Preliminary MRP-227- Rev. 1 RAI Responses

Kyle Amberge-PM
EPRI-MRP

September 6, 2017

Overview of Planned Responses to MRP-227, Revision 1 Requests for Additional Information

MRP-227-Rev. 1 Figure 4-1

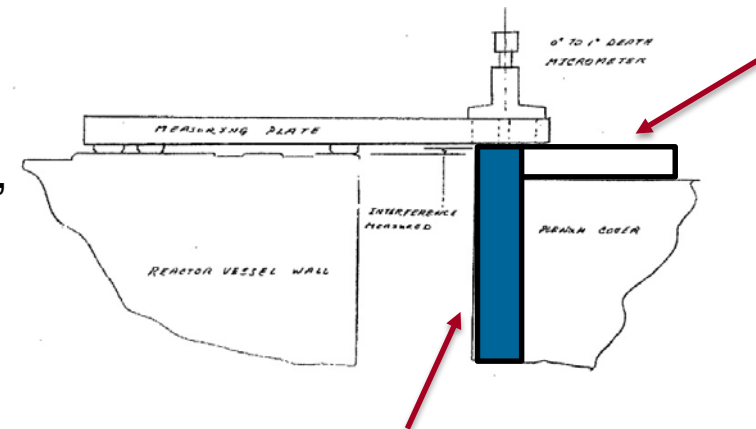
- **RAI Summary:** Why the change of the plenum cover support ring from “A” in MRP-227-A to “Primary” in MRP-227-Rev. 1.
- **Industry Response:** Plenum cover support ring machined to a common plane with the plenum cover weldment rib pads, making it part of the core clamping items.
- Core clamping measurements have been consistently performed at all Babcock and Wilcox-designed units, and included the plenum cover support ring
- Clarifying change only (no technical issues), core clamping measurements always considered the ring and the pads as they are designed to share the load

MRP-227-Rev. 1 Figure 4-9

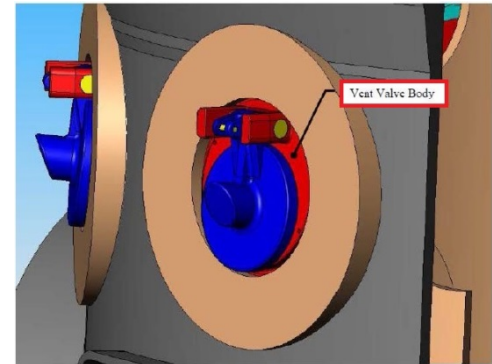
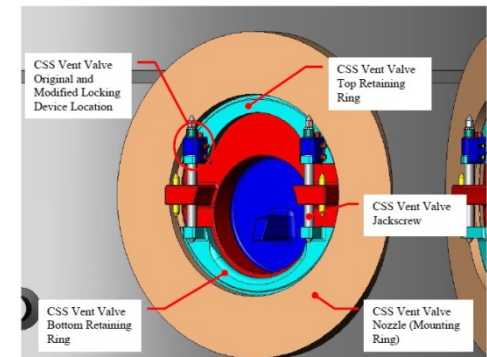
- **RAI Summary:** Why the addition of the vent valve bodies as Expansion link to the CRGT spacer castings (previously they were no additional measures)?
- **Industry Response:** Previously the original vent valve bodies were able to be screened out, but data for replacement vent valve bodies have not been fully gathered, hence they are conservatively screened in unless they can be shown to be below the screening criteria (see Table 4-4 Note 4)
- This may consist of CMTR reviews and/or a statistical argument, PWROG-15032-NP
 - NRC staff performed an assessment of PWROG-15032-NP (ML16250A001)

MRP-227-Rev. 1 Figure 4-2

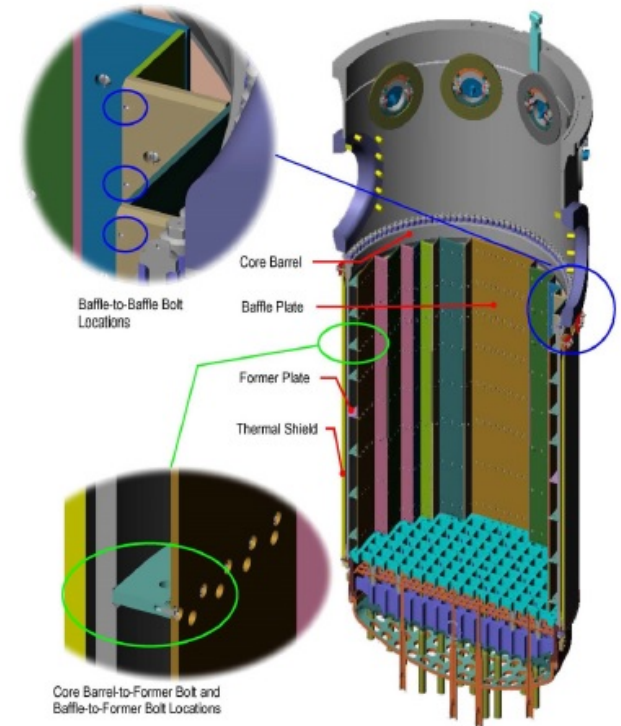
- **RAI Summary:** Does the initial baseline UT examination schedule for the baffle-to-former bolts in MRP-227-Rev. 1 assume an examination of baffle-to-former bolts has been completed within two RFOs from the beginning of the period of extended operation? If not, justify changing the schedule for the baseline UT examinations of the baffle-to-former bolts
- **Industry Response:** Yes, the initial baseline UT examination schedule for the B-F bolts in MRP-227, Rev. 1 assumes an examination of B-F bolts has been completed within two refueling outages from the beginning of the period of extended operation for each operating B&W unit.

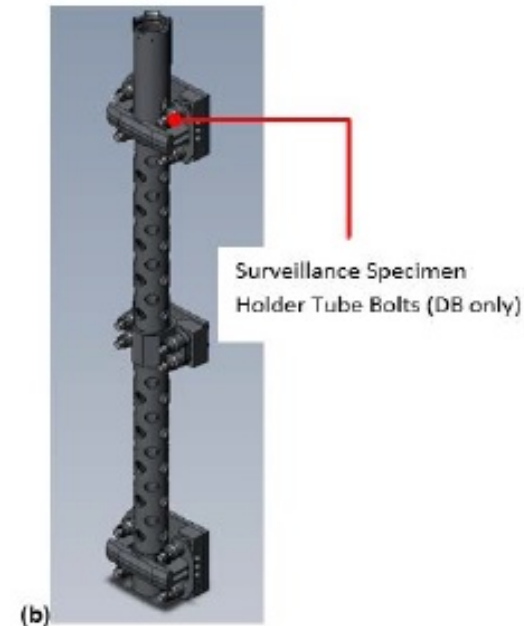
- **RAI Summary:** Is Note 8 in Table 4-1 regarding locking devices and locking device welds for core barrel bolting correct? Is the Expansion link correct?
- **Industry Response:** Both are correct. None of the locking device welds have irradiation-assisted stress corrosion cracking (IASCC) as an applicable aging degradation mechanism, but all bolt locking devices and locking device welds are linked by irradiation embrittlement (IE).
- For clarification, the Table 4-1 entry for the effect (mechanism) for these items will be revised (see next slide, updated text is bold-underlined)

Table 4-1 Primary Item	Effect (Mechanism)
B11.Core Barrel Assembly Locking devices, including locking welds, of baffle-to-former bolts and internal baffle-to-baffle bolts	<u>Locking Devices: Cracking (IASCC, IE) including the detection of missing, non-functional, or removed locking devices (Note 3)</u> <u>Locking Welds: Cracking (IE) including the detection of missing, non-functional, or removed locking device welds (Note 3, 8)</u>

8. The aging degradation mechanism of IASCC is only applicable to the baffle-to-former bolt and internal baffle-to-baffle bolt locking devices, not the baffle-to-former bolt and internal baffle-to-baffle bolt locking device welds. There are no Expansion component items for the baffle-to-former bolt and internal baffle-to-baffle bolt locking device welds for IASCC.

MRP-227-Rev. 1 Figure 4-8(b)

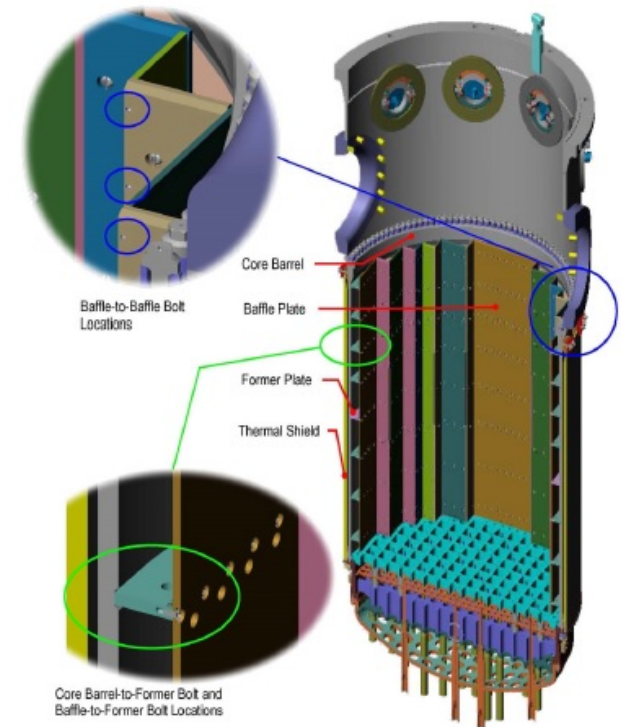
- **RAI Summary:** Why do the SSHT bolts have IC/ISR/Fatigue/Wear applicable in MRP-227-Rev. 1? Were the compression collars left out of the screening and FMECA process as an oversight and are they the same as the locking cups and tie plate in MRP-227-A?
- **Industry Response:** After determining more accurate fluence values for the SSHT bolts, the fluence was determined to exceed the screening criteria for IC/ISR. When IC/ISR is screened in, so are fatigue and wear.
- A plant-specific records search was performed in 2010 for DB and determined the details of the SSHT bolt and locking mechanism for DB, and the use of a compression collar was discovered at that time.
- This component was unknown during the development of MRP-227-A. The locking cups and tie plates are in addition to the compression collar.
- This component only exists at DB.

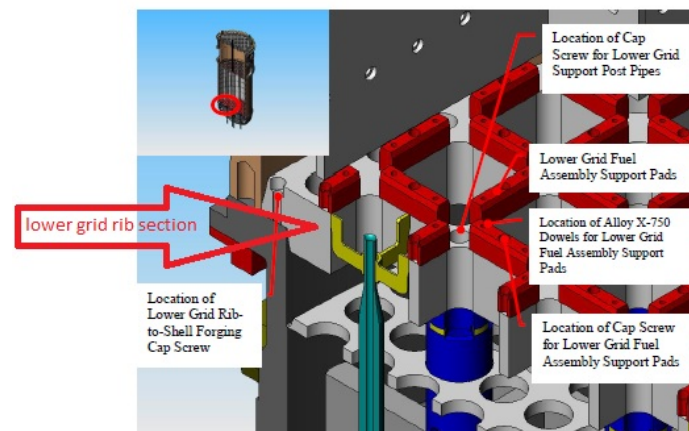
- **RAI Summary:** Explain why the lower grid rib section has been recategorized from “No Additional Measures” to “Expansion.”
- **Industry Response:** The table below shows the changes from MRP-189, Revision 1 to MRP-189, Revision 2. The screening results are the same but the change comes from a reevaluation of the safety consequences and the introduction and use of an IE susceptibility metrics table (Table 4-1 in MRP-189 Rev. 2) in performing the FMECA.

MRP-189 Screening Result	MRP-189 FMECA Result	MRP-231 Aging Management Strategy Result
Lower Grid Rib Section in MRP-189, Revision 1	Category “Not A” for IE	Category “A” based on susceptibility of B and safety consequence of 1	Category “A” (not considered in MRP-231)
Lower Grid Rib Section in MRP-189, Revision 2	Category “Not A” for IE	Category “C” based on susceptibility of C and safety consequence of 2	Expansion (to Baffle Plates)

MRP-227-Rev. 1 Figure 4-2

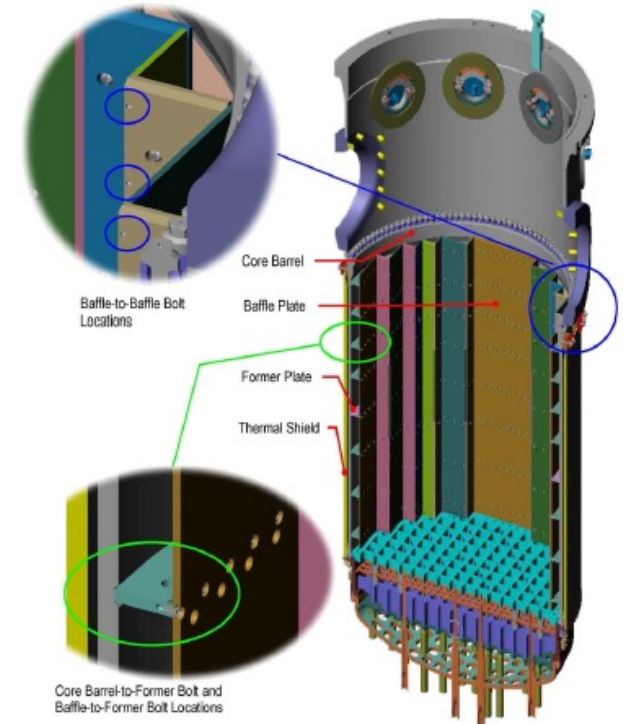
- **RAI Summary:** Explain why the language regarding rows 3, 4, and 5 and 25% of the bolts on a single plate was removed from the Expansion criteria of the baffle-to-former bolts.
- **Industry Response:** The Expansion criteria were updated to include only considerations for determining that an active aging degradation mechanism in the baffle-to-former bolts is underway. Aging degradation drives the Expansion inspections.
- Note that clustering of failures of baffle-to-former bolts is not expected in the Babcock & Wilcox-designed units, per Customer Service Bulletin 16-02 (July 2016), which are all original upflow configuration.
- This also supported by operating experience to date in the Babcock & Wilcox-designed units.

MRP-227-Rev. 1 Figure 4-2

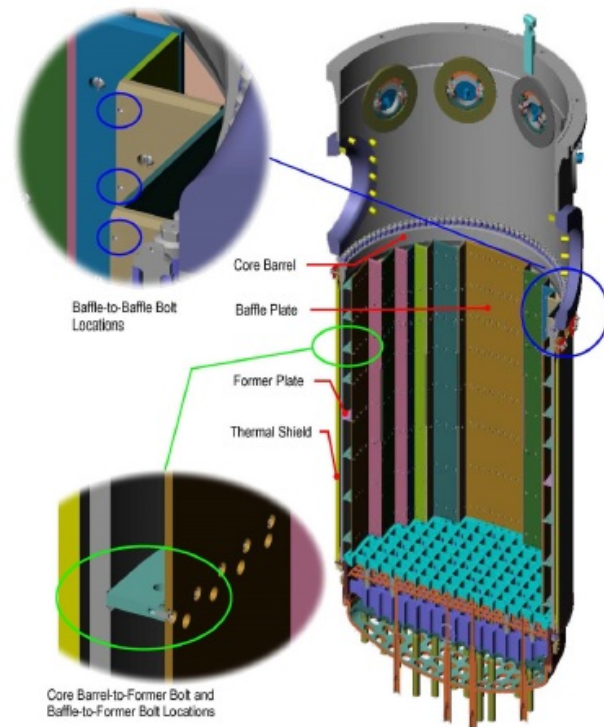
- **RAI Summary:** Provide technical justifications for the change in relevant condition and Expansion criteria text for the baffle plates. Clarify whether Expansion is only required if cracking links two or more openings or whether Expansion would be required if cracking is present within one inch of any opening.
- **Industry Response:** Due to the nature of irradiation embrittlement, this examination acceptance criteria is appropriate.
- Units have examined the baffle plates and thus far no relevant conditions have been identified
- The Expansion criteria entry currently listed in Table 5-1 of MRP-227-Rev. 1 for the baffle plates will be updated to be consistent with the relevant condition, as noted on the next page (updated text is bold-underlined).

Primary Item	Applicability	Primary Item Examination Acceptance Criteria	Expansion Link(s)	Expansion Criteria	Expansion Item Examination Acceptance Criteria
Core Barrel Assembly Baffle Plates	All plants	Visual (VT-3) examination The specific relevant condition is readily detectable cracking connecting openings in the baffle plates (i.e., bolt hole <u>or</u> flow hole).	Former plates Core barrel cylinder (including vertical and circumferential seam welds) Lower grid rib section	<u>Confirmed evidence of readily detectable cracking connecting one or more openings in the baffle plates (i.e., emanating from a bolt hole or a flow hole) shall require:</u> a) An evaluation of the former plates and the core barrel cylinder for the purpose of determining continued operation or repair/replacement by the completion of the next refueling outage. Alternatively, repair/replacement activities may be initiated based on results of a best effort former plate and core barrel cylinder examination. b) That the VT-3 examination be expanded by the completion of the next refueling outage to include 100% of the lower grid rib section heat-affected zones adjacent to the IMI guide tube spider-to-lower grid rib section welds.	N/A

MRP-227-Rev. 1 Figure 4-3

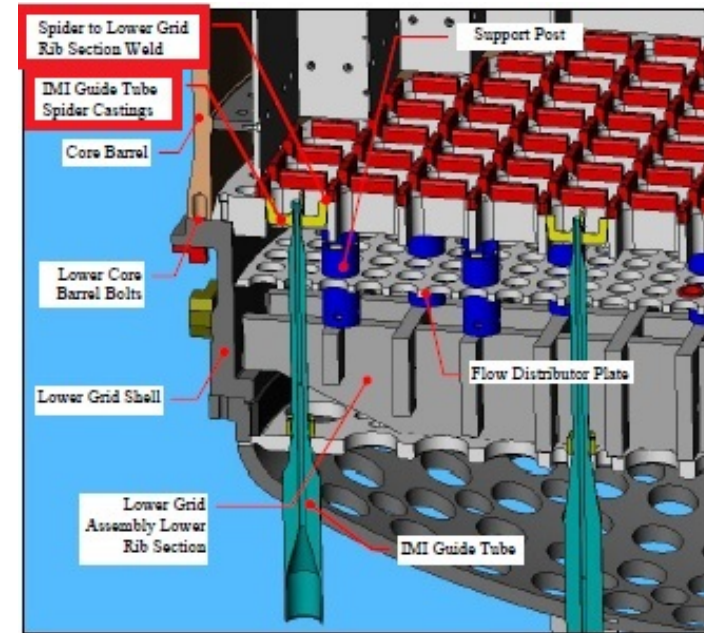
- **RAI Summary:** Explain why the examination coverage for the IMI guide tube spiders changed from “100% of top surfaces of 52 spider castings and welds to the adjacent lower grid rib section” to “Spiders: 100% of the accessible top surfaces and 100% of the accessible spider surfaces adjacent to the spider casting welds” and “Spider welds: 100% of the accessible welds to the adjacent lower grid rib section.”
- **Industry Response:** This is a clarification of the examination coverage by separating the spiders from the welds and does not change the actual inspection coverage.
